AUDITING ENERGY SYSTEM EFFECTIVELY

By K.K.PARTHIBAN, Boiler Consultant

AUDIT OF 12 TPH AFBC BOILER UNDER SUPPLY

Photo 4: The gas turning vanes at MDC shall be at a uniform height inside the MDC cone. The gap between the outlet pipe & turning vanes shall be closed by a round rod. Otherwise the outlet pipe erodes.

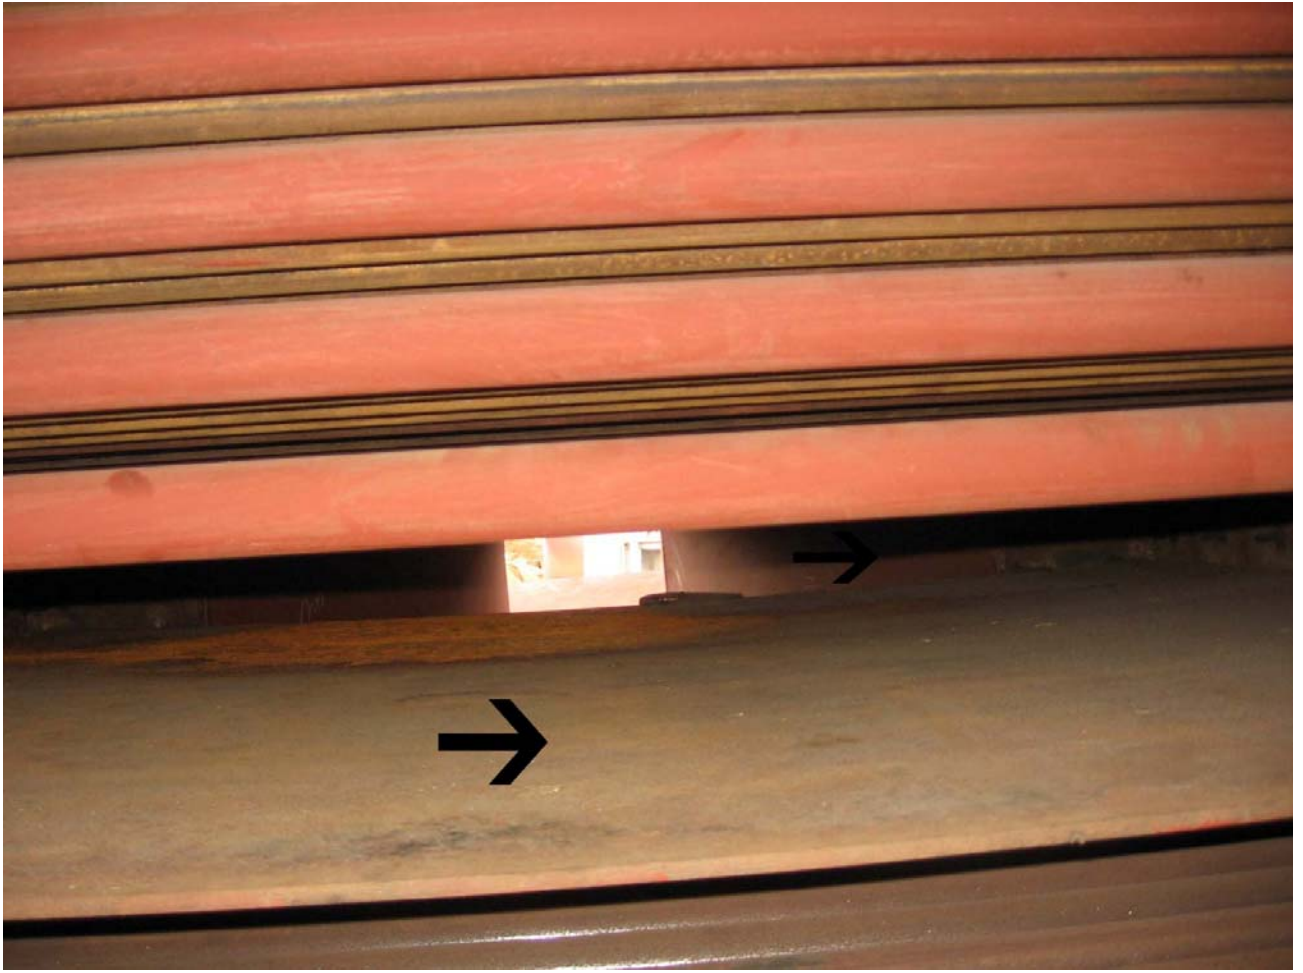
13. MDC cone to vane assembly is not proper. All the turning vanes should be at same level inside the cone. See photo 4.
 14. The waterwall on thermal expansion will try to push the refractory wall. To take care of thermal expansion ceramic blanket can be inserted for 20 mm thick at the joint between the waterwall & refractory wall.

15. MDC outlet pipe to vane clearance is too high. This gap shall be filled with a 5 mm rod all around to prevent erosion of outlet tubes.
-

Photo 5: The APH tube to middle baffle gap is too high. This can bypass the gas affecting the APH performance.

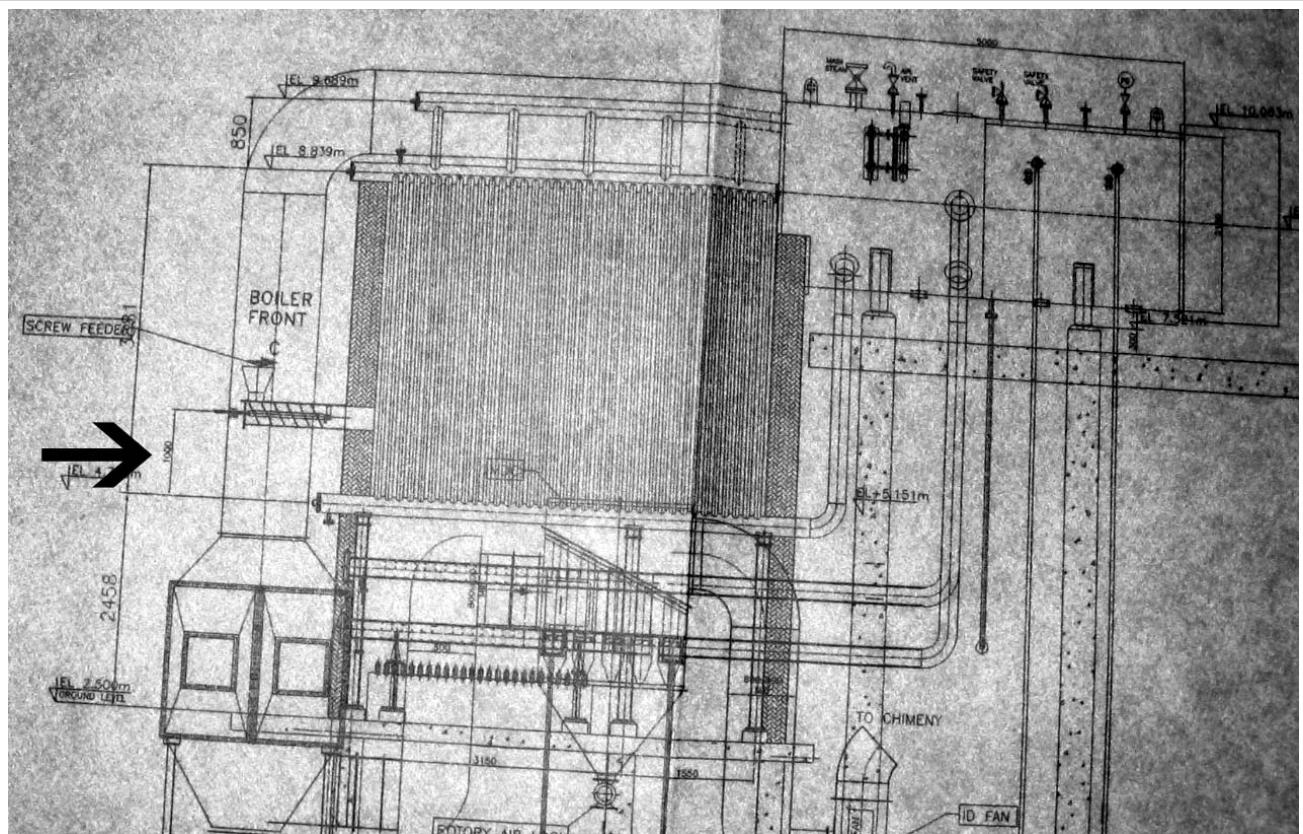
4. The APH inside tube arrangement is not OK. There is big gap of 150 mm on either side of the central baffle. See photo 5. This needs to be corrected.

Photo 6. The elevation of screw feeder is too high to bed coil level. Check what is in the present boiler and provide the same. Recommended distance is 300 mm above bed coil.

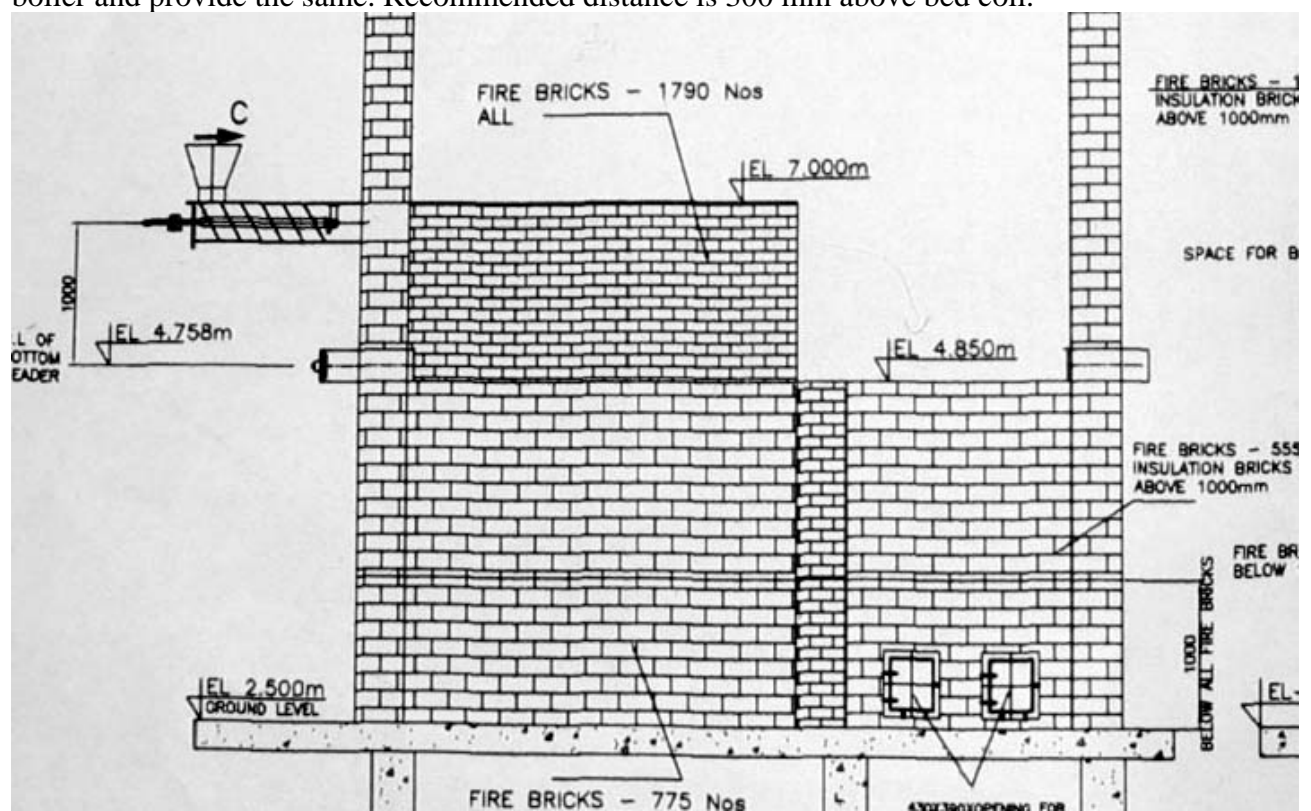
5. The fuel feed point seem to be at a very high level over the bed tubes. See photo 6. Please compare the fuel feed point in the available 8 TPH boiler and revise the location suitably. My recommendation would be 300 mm above bed coil so that the husk will get in to the bed.

Photo 1-3: Photos above illustrate the ash fouling above coal nozzles. Blunting of outer studs is seen.

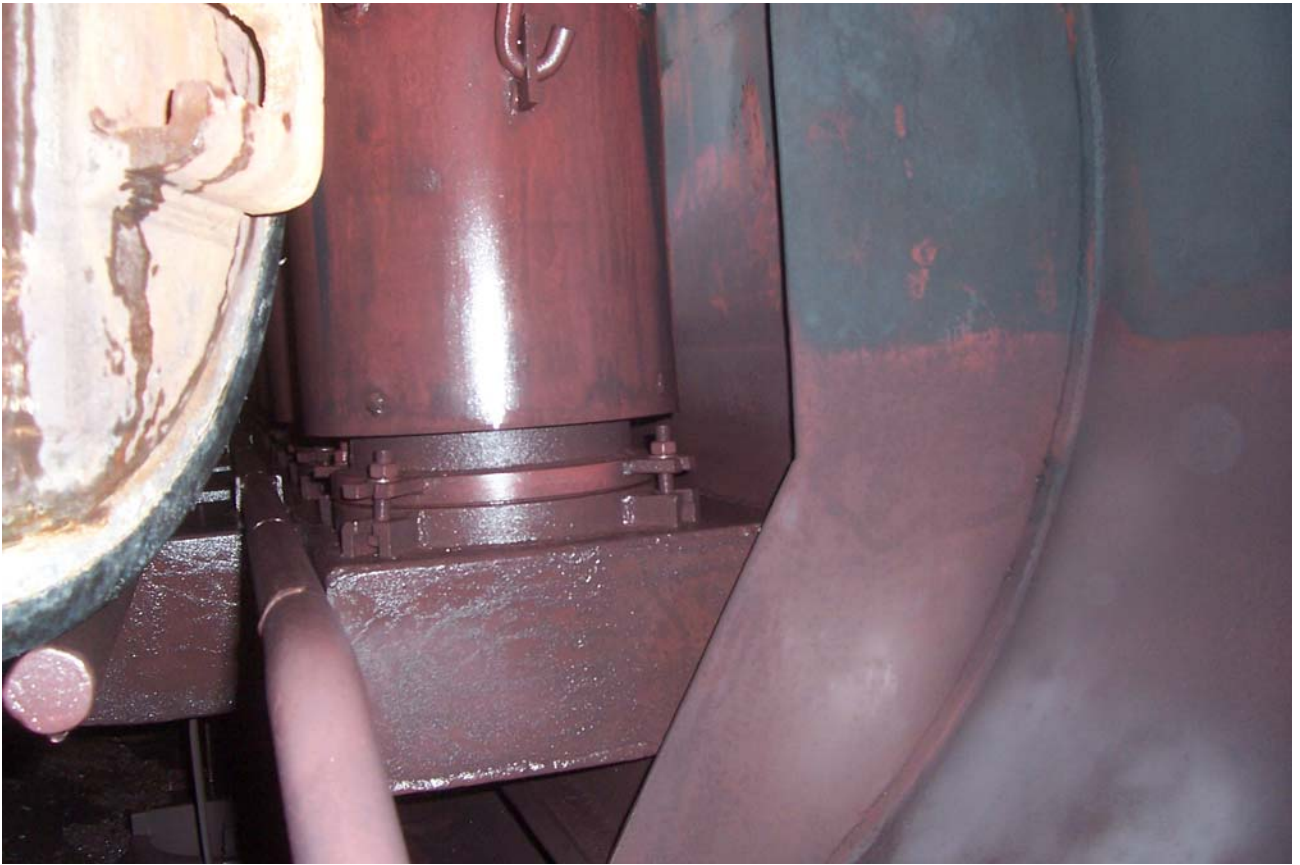
1. The fluidised bed was clean at the time of inspection. The bed coils were externally inspected for any sign of erosion. There were no marks of erosion, though there was no protection system such as shields or phoscast refractory. However there were marks of ash deposition / fouling above all fuel points. See the photographs 1, 2 & 3. At all fuel points the fouling of ash was seen to a radius of 250 mm. The fuel used has a low ash fusion temperature.

Photo 4 & 5: Photos above illustrate the boiler is corroding. The distinguished red color in water space proves the boiler water chemistry regime is not OK.

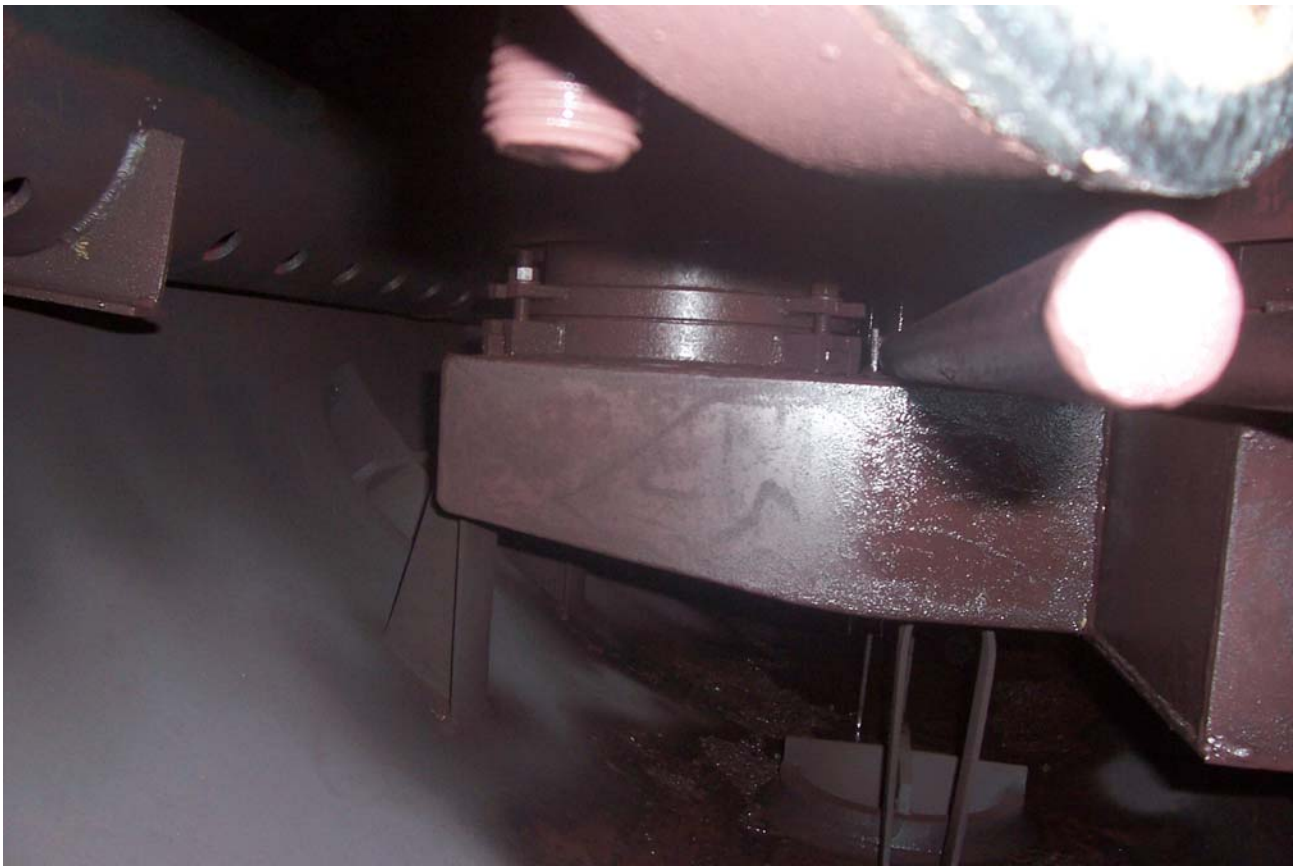
4. It was informed that the boiler water pH & phosphate were maintained properly after the first failure. The drum was opened and inspected. The photographs taken (see enclosed photo 4 to 7) revealed that the boiler is yet subject to corrosion. The color of the drum in the water zone is still reddish. The drum internal design needs to be changed to correct this. Right now the chemical dosed can easily go to CBD line as the two lines are close to each other. By this, the sample drawn from CBD will always indicate higher PO₄ & pH as compared to circulating water. The chemical dosing line can be brought under the feed water distributor. See photograph no 8 for a good drum of another manufacturer with right type internal.

Figure 2: Economizer to be given baffles as shown in future.

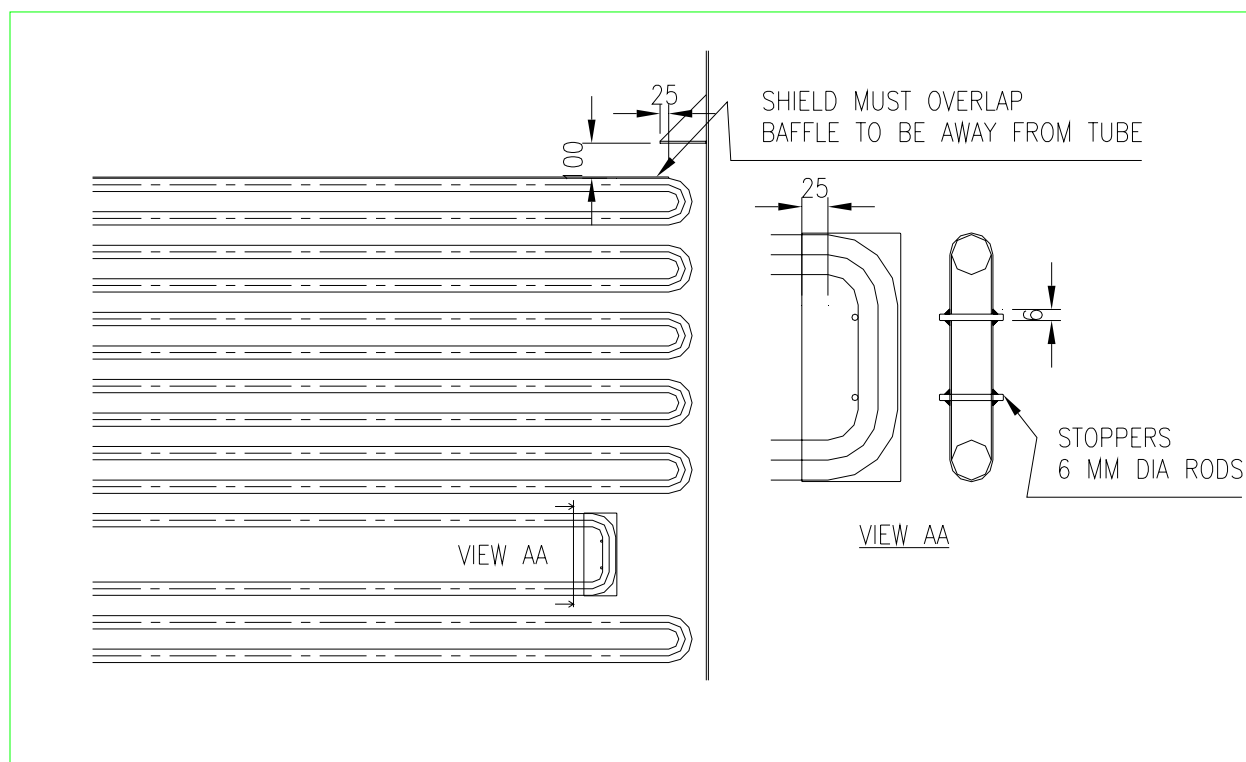
7. The APH erosion was seen in the lower block. The cause for the failure was the excessive tube to casing plate clearance. See photograph 14. As the flue gas tends to go through the excessive gap, the erosion is also more. The tube had thinned down at 3⁰ clock position that is facing the casing. The idea of plugging the tube increases the pressure drop to some extent. But yet it may not affect the boiler steam generation, In future if the tubes are replaced at this place, the failure can not be prevented. It is better to leave the tubes as sacrificial tubes. When the tubes loose their shape, they must be replaced. Gas baffles can be provided at the entry and at exit as it is done at economizer inlet and as shown in figure 2.

10. The economizer is found to be eroding. The reason for the erosion could be the high gas velocity adopted. The top baffles provided by manufacturer to prevent bypassing of gas through the end gaps are not fully welded to casing. The width of the baffles shall be 100 mm only. Presently it is more than 200 mm reducing the gas flow area. The baffles are not to be too close the tubes. As the ash stocks and falls off from the baffle, the flue gas tends to cut the tube. It is necessary to leave a gap of 100 mm above the tubes. Also the tubes need shields for erosion protection as shown in the figure 2.

12. The tube bends of economizer were found to be eroding in between the banks. The tubes can be provided with cassette baffles as shown in the figure 2.
